TRANS/WP.29/2005/39
7 April 2005

World Forum for Harmonization of Vehicle Regulations (WP.29)
(One-hundred-and-thirty-sixth session, 21-24 June 2005,
agenda item 4.2.1.)

PROPOSAL FOR DRAFT SUPPLEMENT 12 TO THE 09 SERIES OF AMENDMENTS TO
REGULATION No. 13

(Braking)

Diagram 1

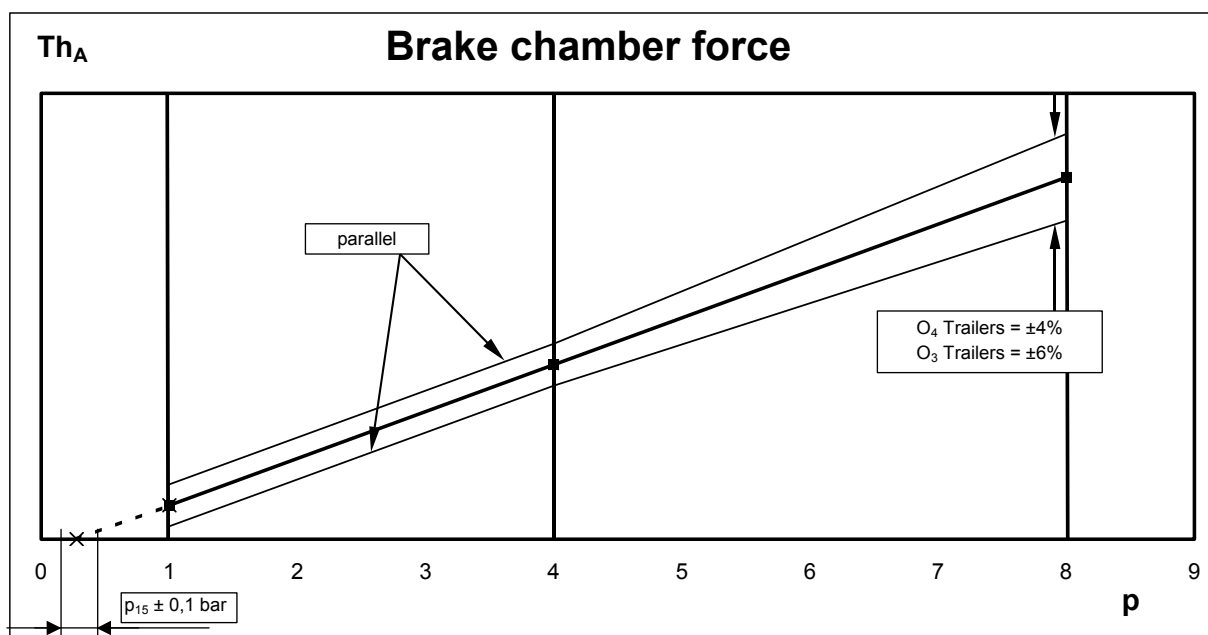
2.3.2. With respect to the verification of average thrust (Th_A) - $f(p)$, a graph defining the acceptable performance variation shall be constructed following the model shown in Diagram 1, which is based on the manufacturers declared thrust to pressure relationship. The manufacturer shall also define the category of trailer for which the brake chamber may be used and the corresponding tolerance band applied."
